New Opening Date, Clarifications to the Specifications and

Bid Item #23-187 Augusta Regional Airport Gates 3 and 4 Terminal

ADDENDUM NO. 1

A-131

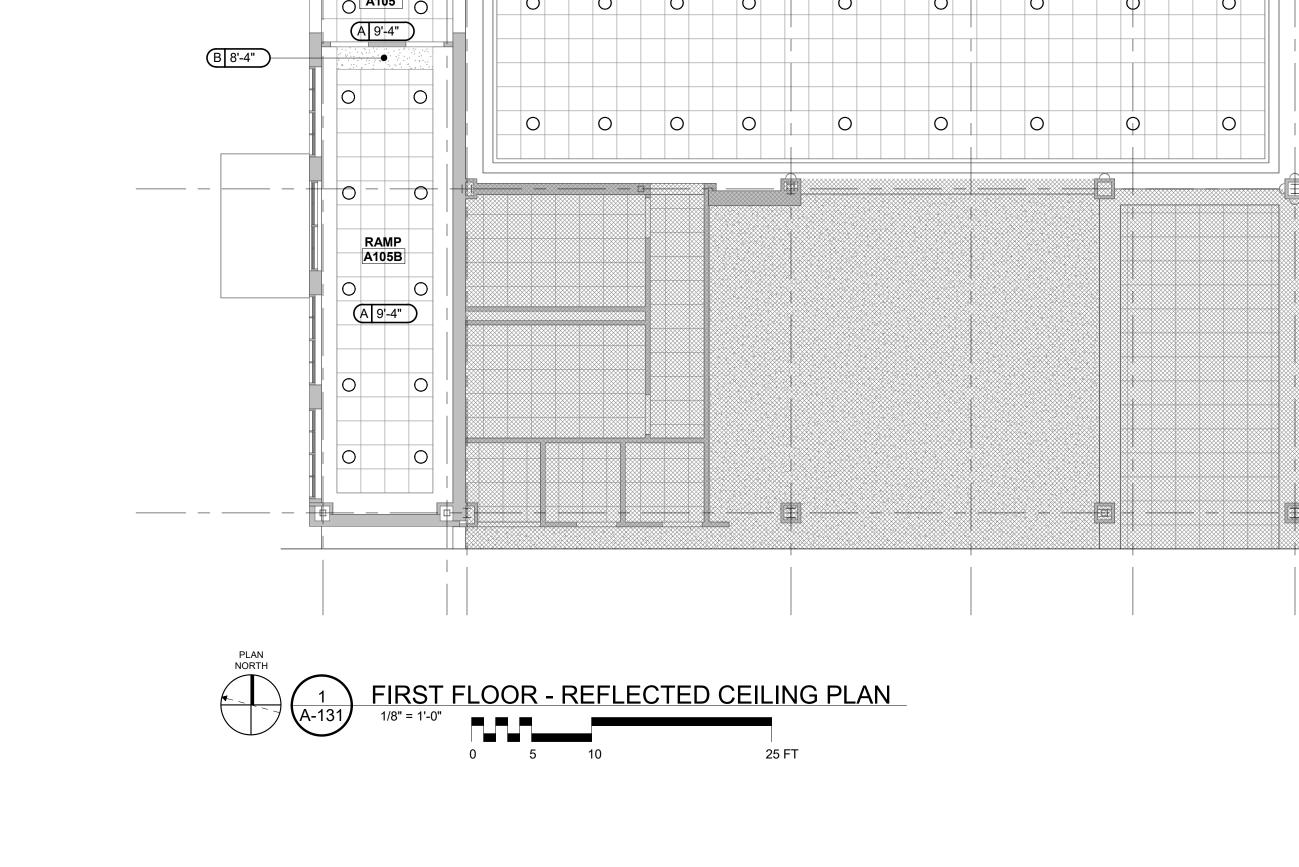
- c. Revised Phasing Plan Keynotes.
 - d. Revised Phasing Plan Legend.
 - e. Added General Note 3.
- 3. Replace Sheet A-131 First Floor Reflected Ceiling Plan with Revised Sheet A-131 First Floor Reflected Ceiling Plan herein attached. Revisions include:

- a. Revised General Note 25.
- 4. Replace Sheet A-311 Wall Sections with Revised Sheet A-311 Wall Sections herein attached. Revisions include:
 - a. Revised Wall Section detail 1 / A-311.

DO NOT SCALE DRAWINGS SHEET CONTENTS WALL SECTIONS

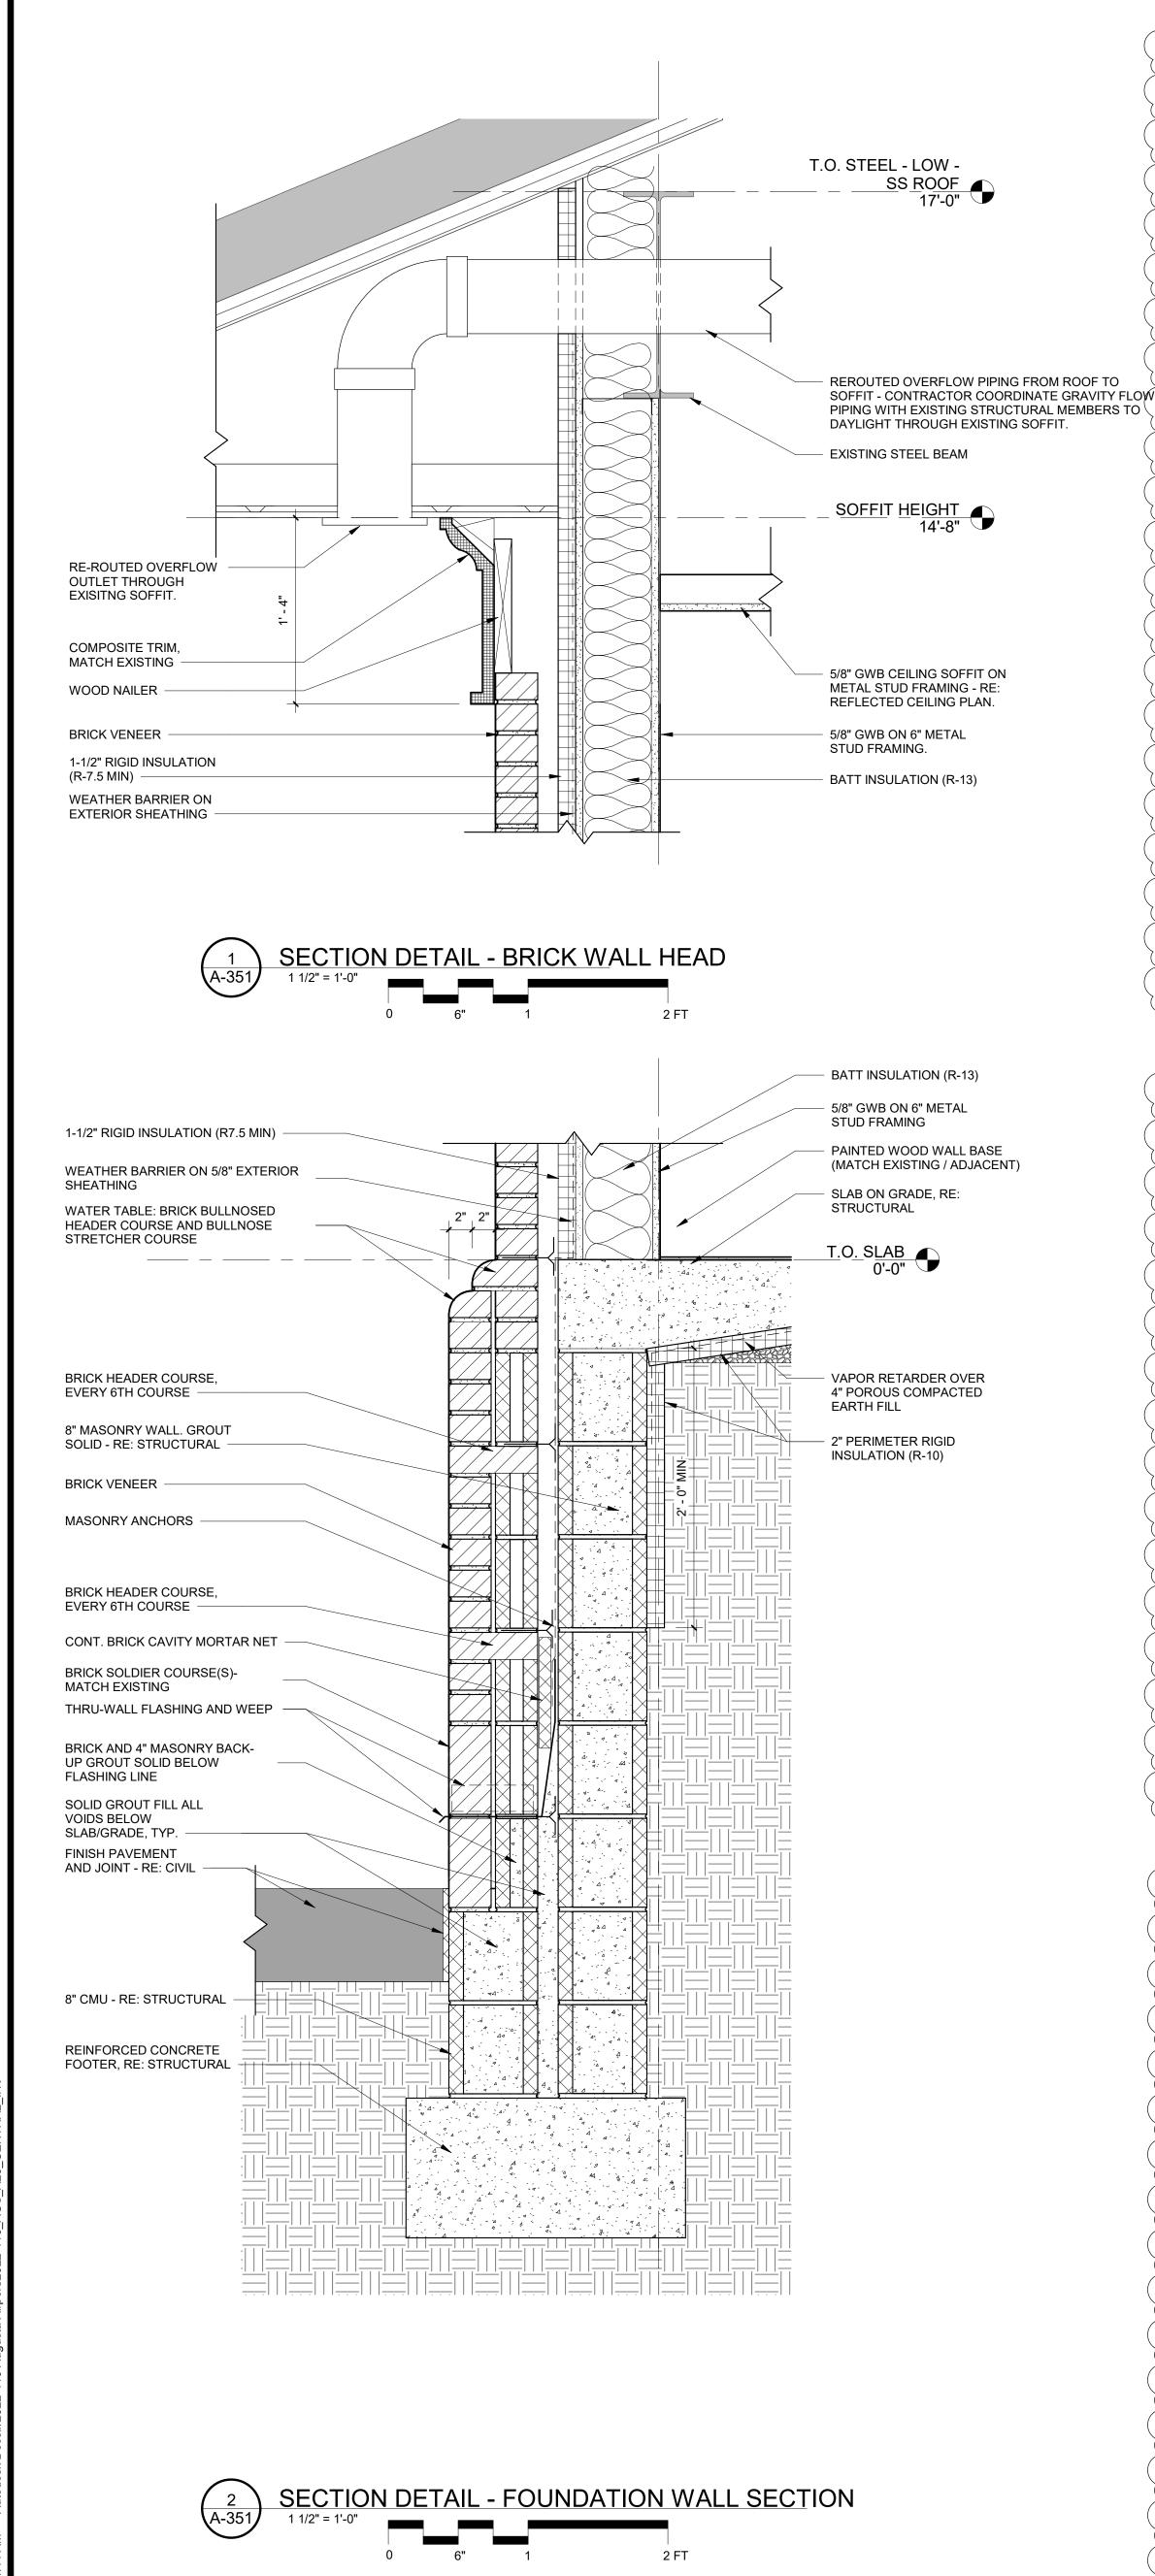
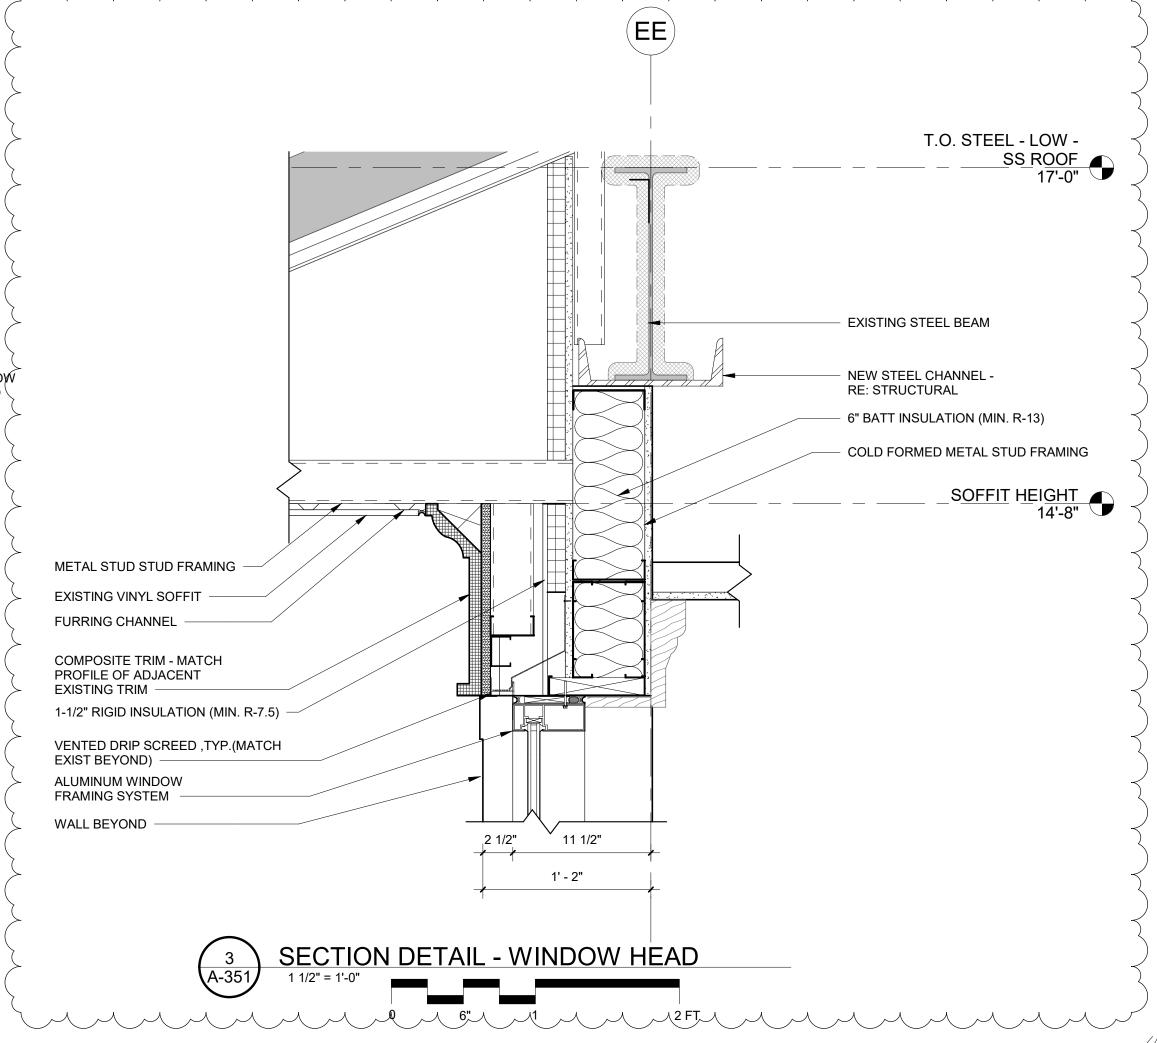
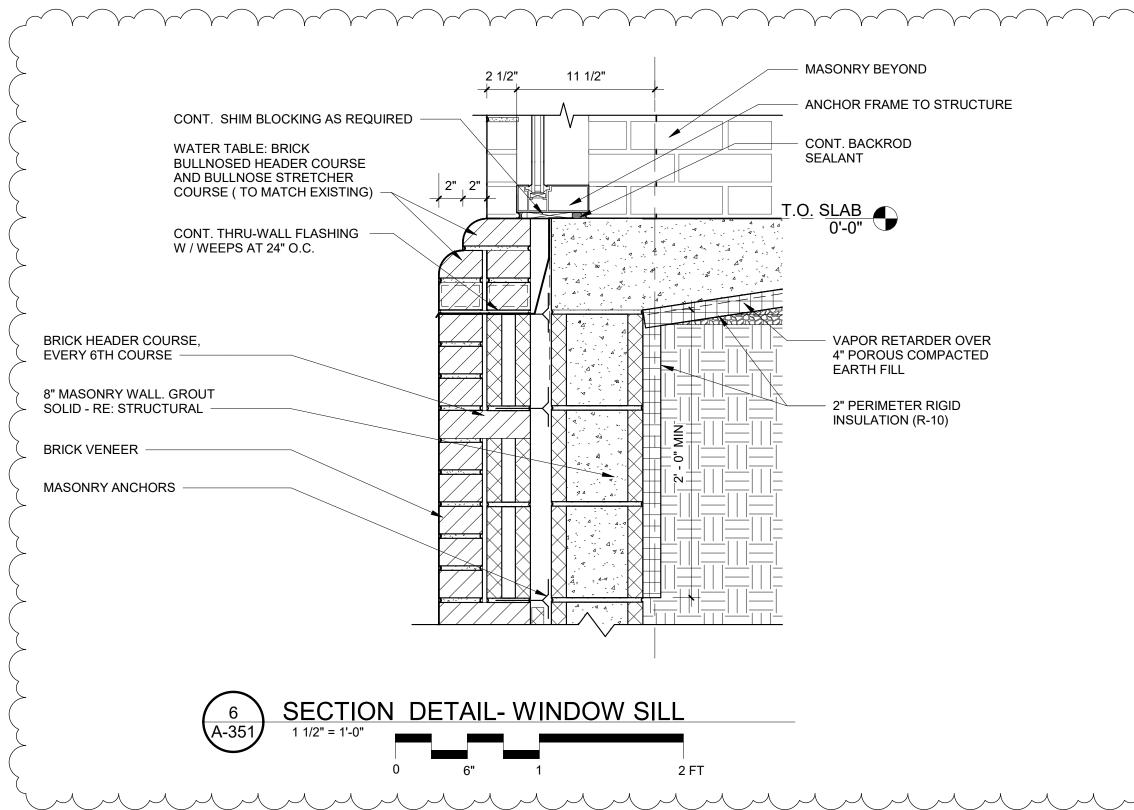
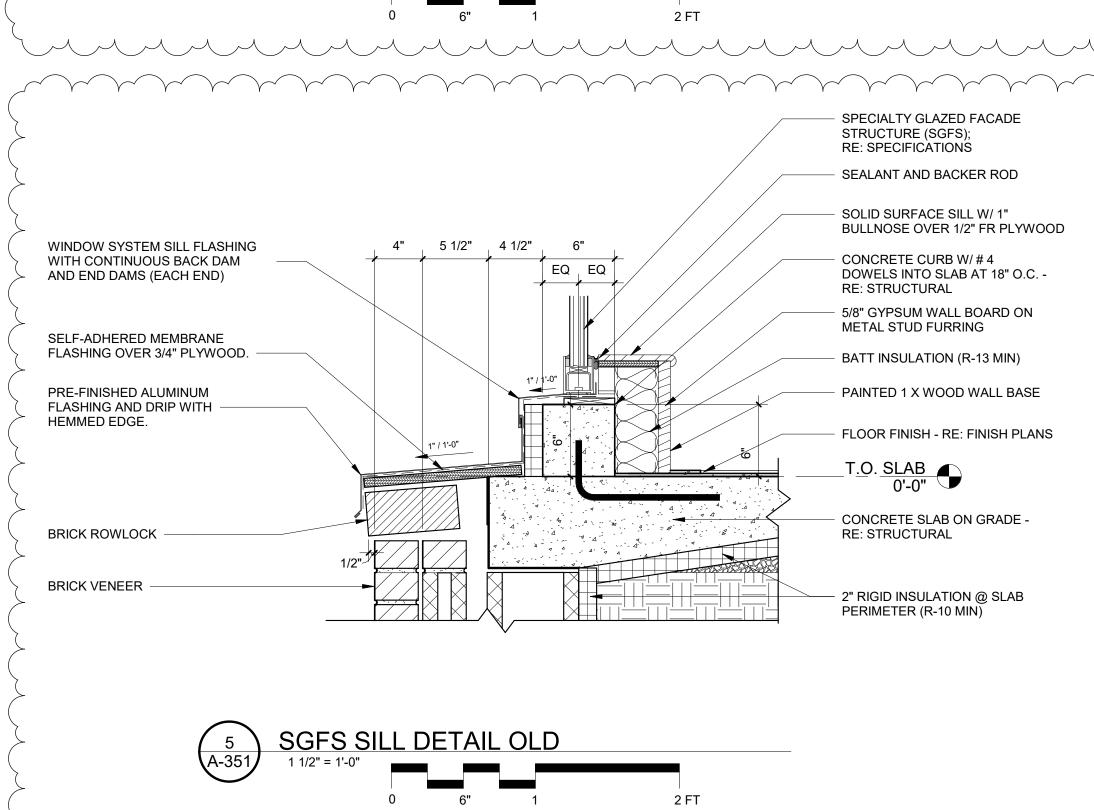
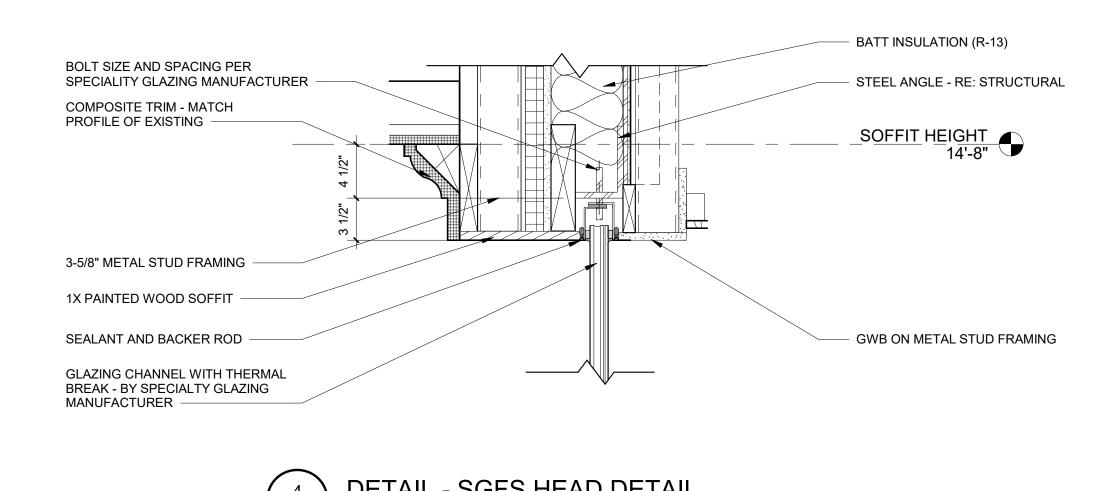
- 5. Replace Sheet A-312 Wall Sections with Revised Sheet A-312 Wall Sections herein attached. Revisions include:
 - a. Revised Wall Section detail 1 / A-312.

- b. Revised Wall Section detail 3 / A-312. Updated detail callout references.
- 6. Replace Sheet A-351 Section Details with Revised Sheet A-351 Section Details herein attached. Revisions include:

SHEET CONTENTS SECTION DETAILS

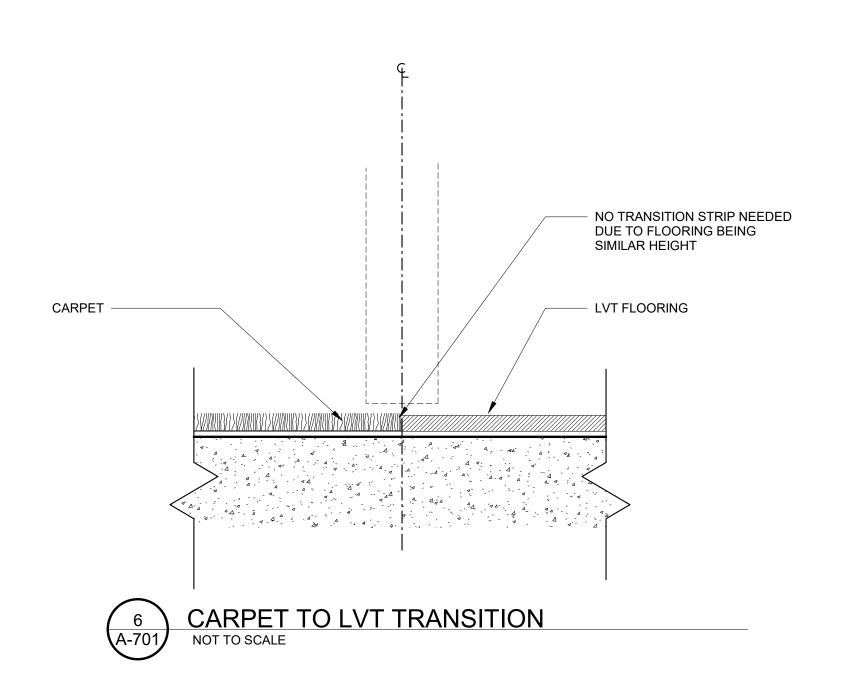
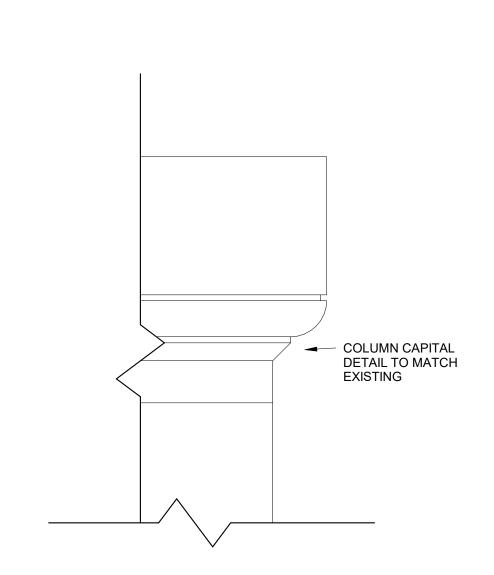
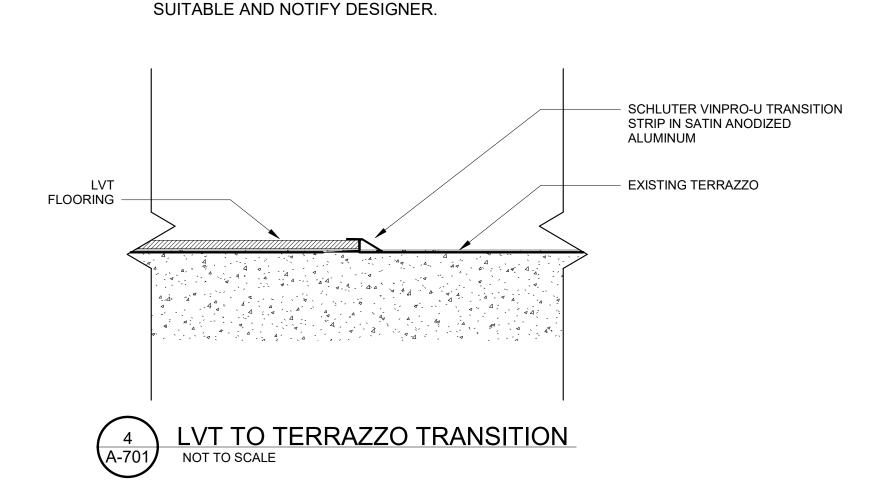
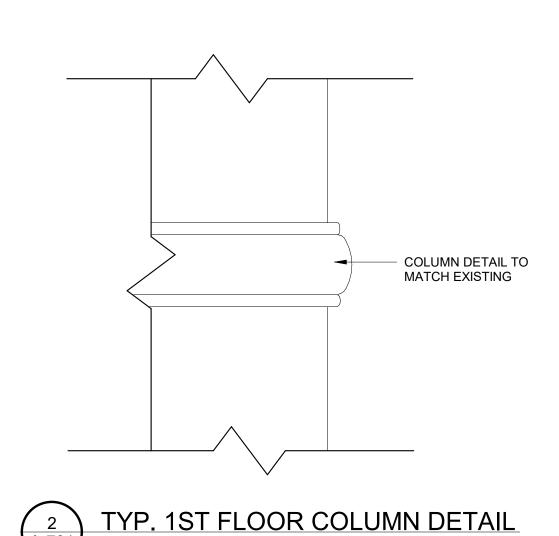
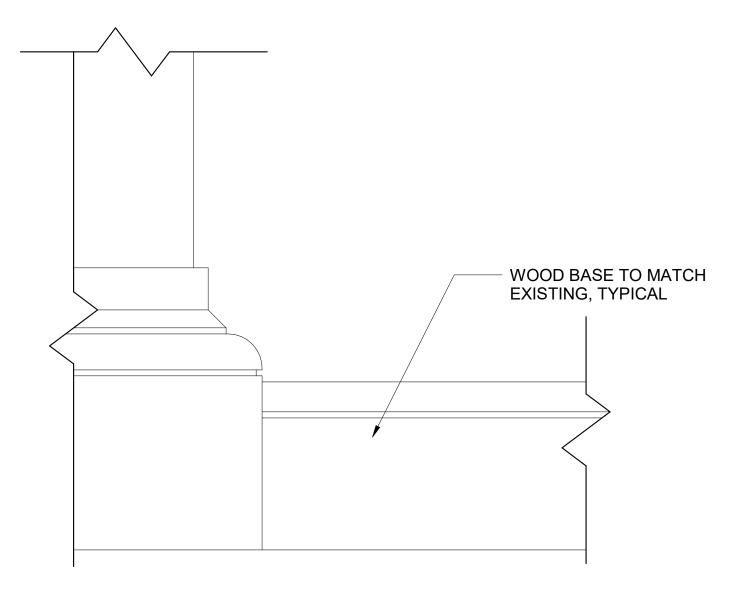
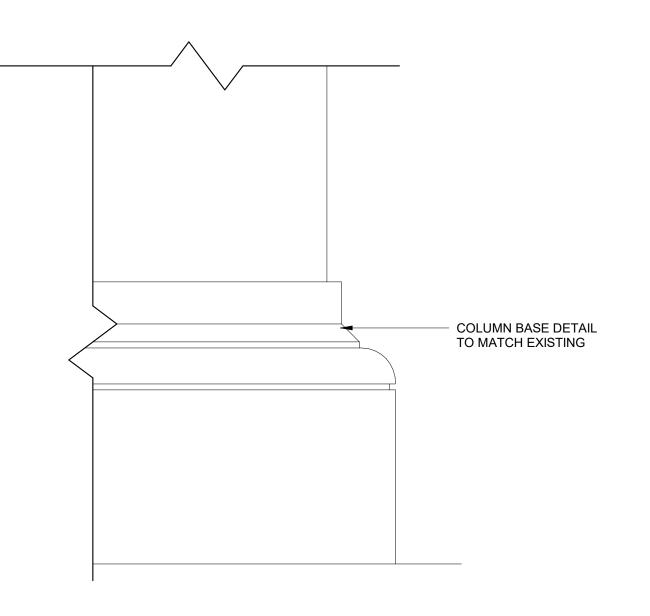
- a. Revised Section detail 3 / A-351.
 - b. Added Section detail 6 / A-351.
 - c. Revised Section detail 5 / A-351.
- 7. Replace Sheet A-701 Room Finish Schedule & Finish Material Specs with Revised Sheet A-701 Room Finish Schedule & Finish Material Specs herein attached. Revisions include:
